RE: Vernon Hydroelectric Project (FERC No. 1904; LIHI Certification #40)  
Comments on LIHI Recertification Application

This letter is regarding the pending application by Great River Hydro, LLC (GRH) for the Low Impact Hydropower Institute's (LIHI) recertification of the Vernon Hydropower Project, located on the Connecticut River in Vermont and New Hampshire.

**Figure A. Northeast Barrier Prioritization for Anadromous Fish**

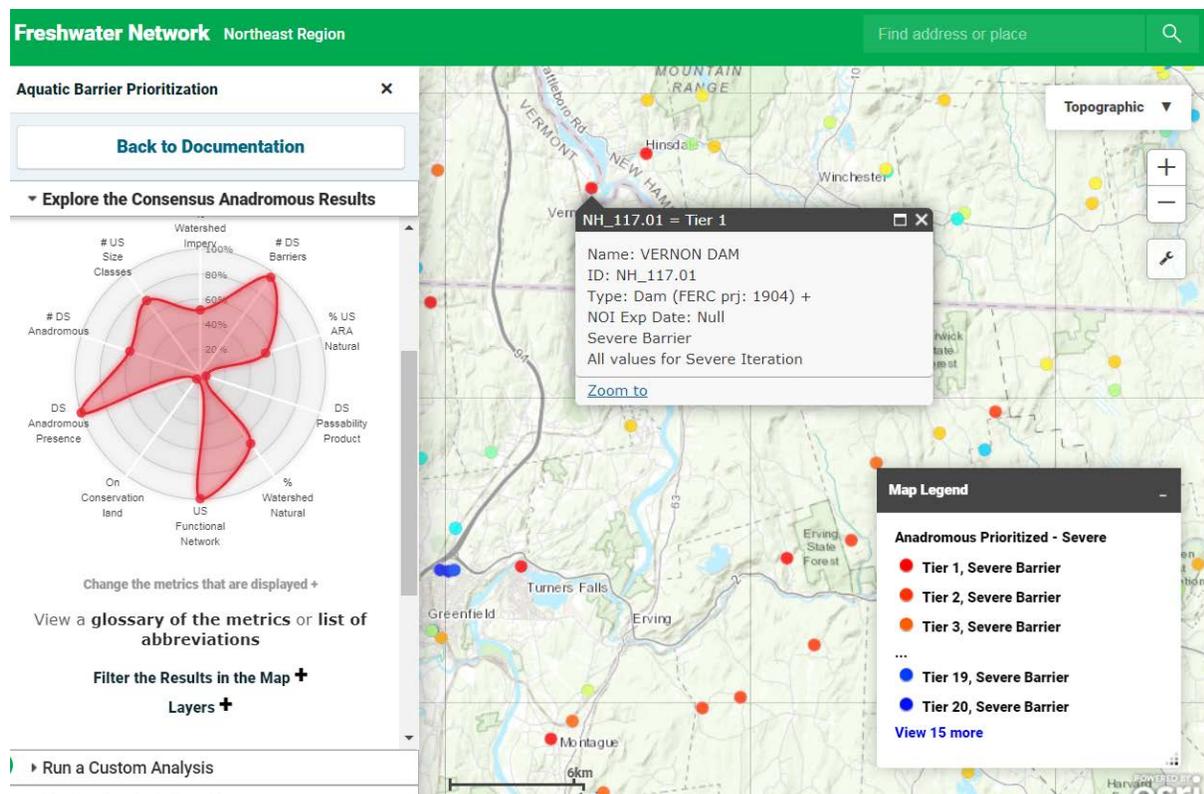
In reference to the following two criteria, note that in the Northeast barrier prioritization for anadromous fish<sup>4</sup>, the Vernon project ranks in the top tier as a severe barrier for migratory fish populations (see Figure A). Unless a barrier in this category has clearly demonstrated safe and effective up and downstream passage, it cannot be supportive of migratory species that are able to

“successfully complete their life cycles” nor can it “maintain healthy, sustainable fish and wildlife resources.”
